Informal document **GRSG-116-31**
(116th GRSG, 1-5 April 2019
agenda item 6(a))

Proposal for GTR No. 6 Safety glazing

Integrated interior mirror

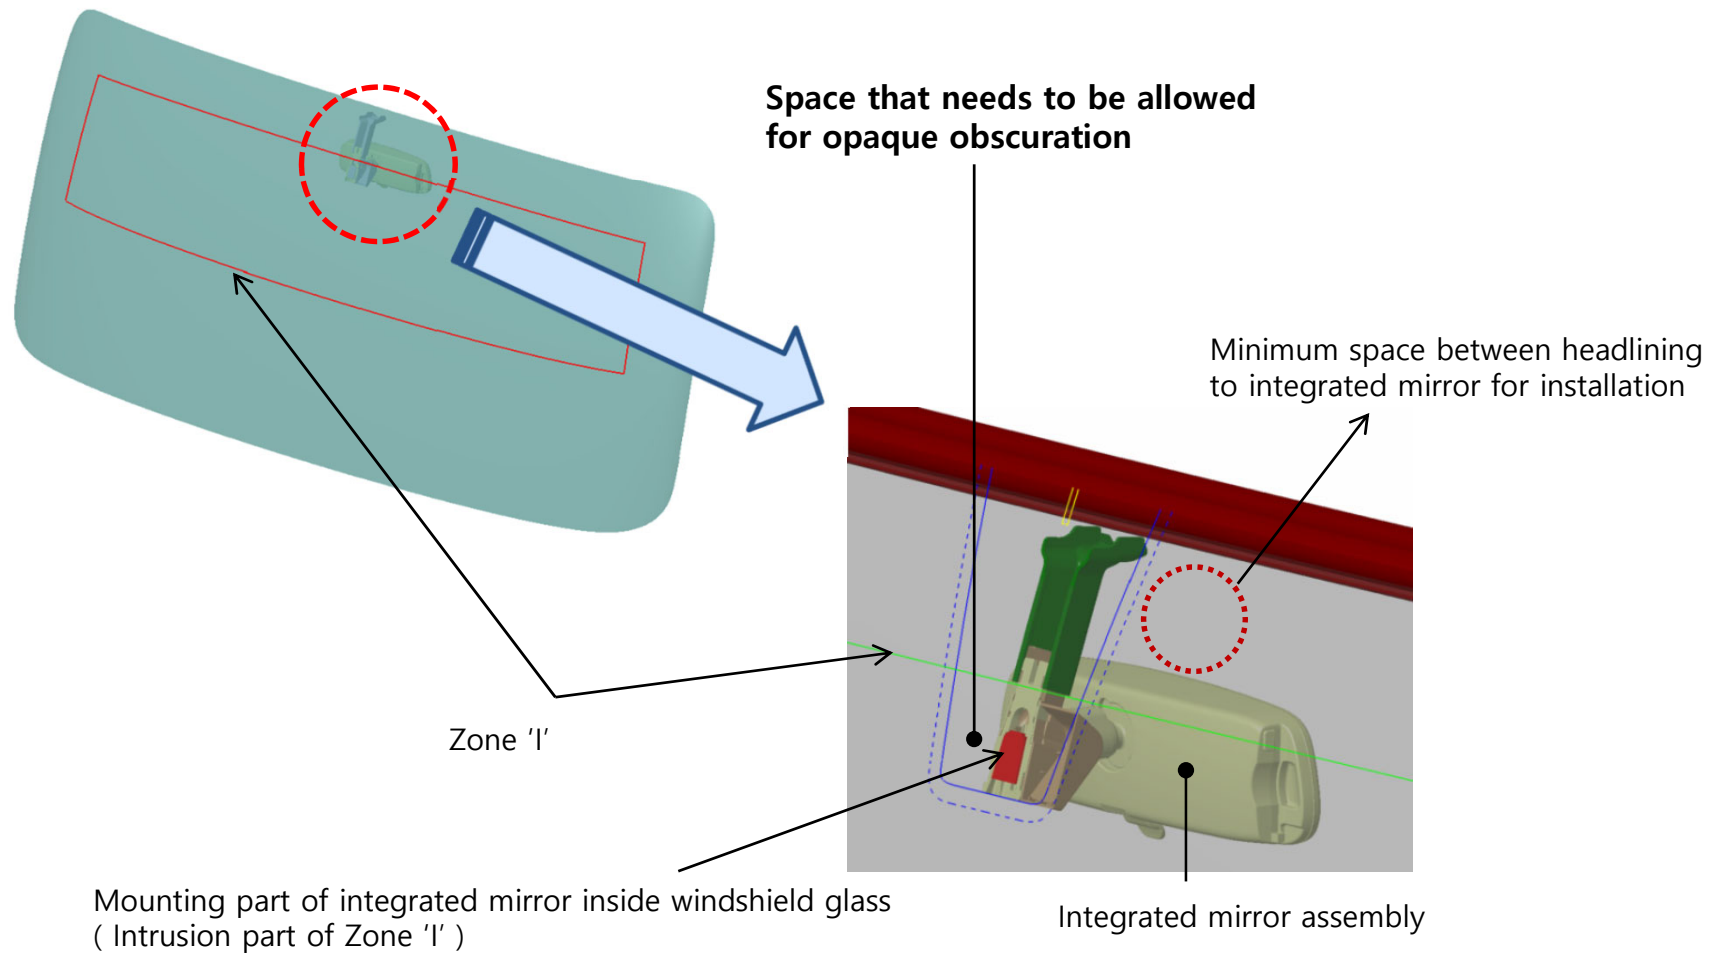
4. However it is difficult for some models to install the interior mirror, since Area "I" may be intruded.

Comparison of front vision

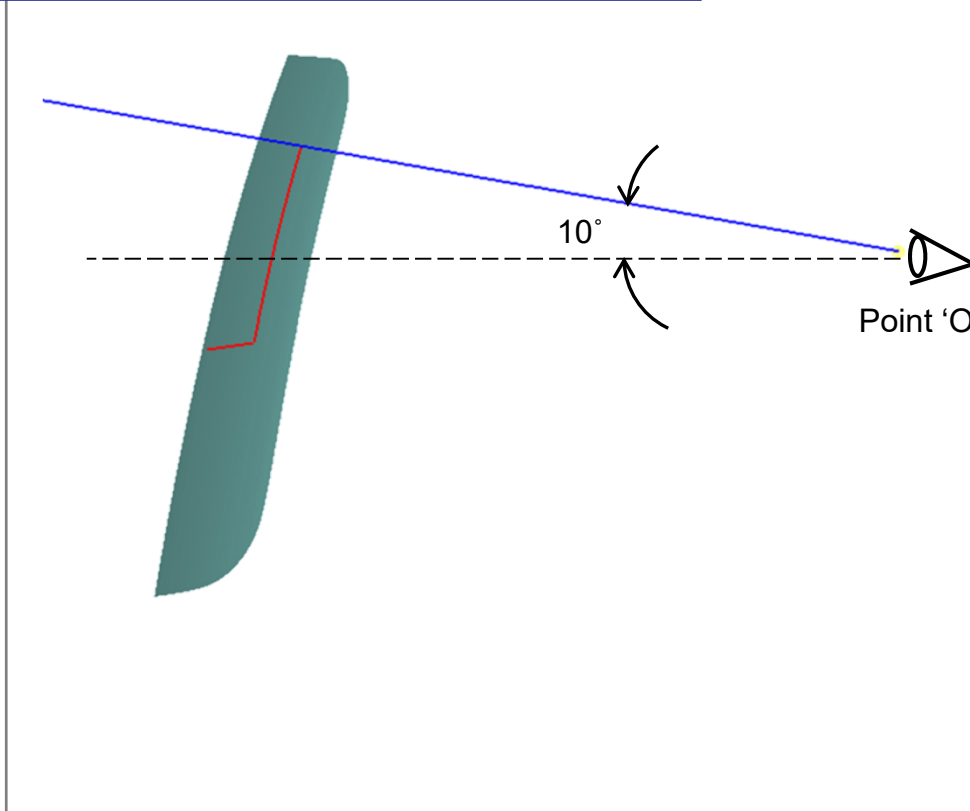
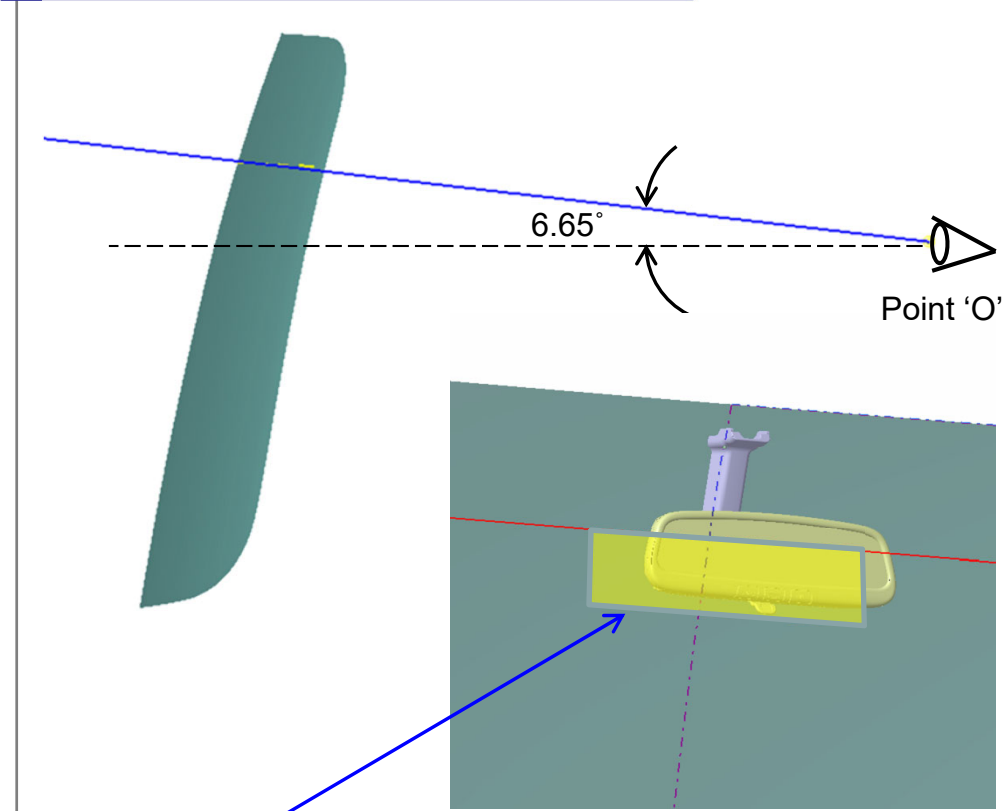
Therefore, the opaque obscuration which is defined in paragraph 7.1.3.2.4. of Annex is needed to be exempted in Zone I, in order to install integrated interior mirror.

The driver's front vision may be intruded by the opaque obscuration(yellow color), but most of the opaque obscuration is already obscured by the interior mirror.

► Result : There is no problem with Front vision angle
